# NOTICE OF DECISION

## ADMINISTRATIVE DECISION - MINOR HISTORIC REVIEW

CASE NO.: Historic Review Case 17-21 / Amanda No. 17-109230-DR

**SUMMARY:** A proposal to repair a sidewalk panel, install a new heat pump and replace windows on the Webb House (1930).

West side of house.

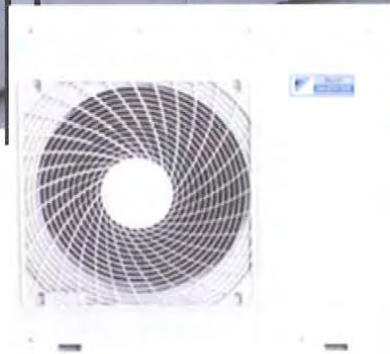
**Finding:** The proposed new heat pump will be located on the west façade of the resource, a secondary façade not visible from the right of way, thereby meeting 230.025(2)(A).

**Finding:** The proposed new HVAC unit will be 29" tall, 32" wide and 12" deep, placed on a 14" x 34" cement pad adjacent to the resource. The refrigeration line will be hidden within a metal 'line hide' (4" in diameter). This line will extend along the western facade 10' 6" from the unit up to the soffit at the roofline, not easily visible from the right of way. Staff finds SRC 230.025(g)(2)(C) has been met for this proposal, and that the proposed new HVAC unit is limited in size and scale, and compatible with the Webb House.
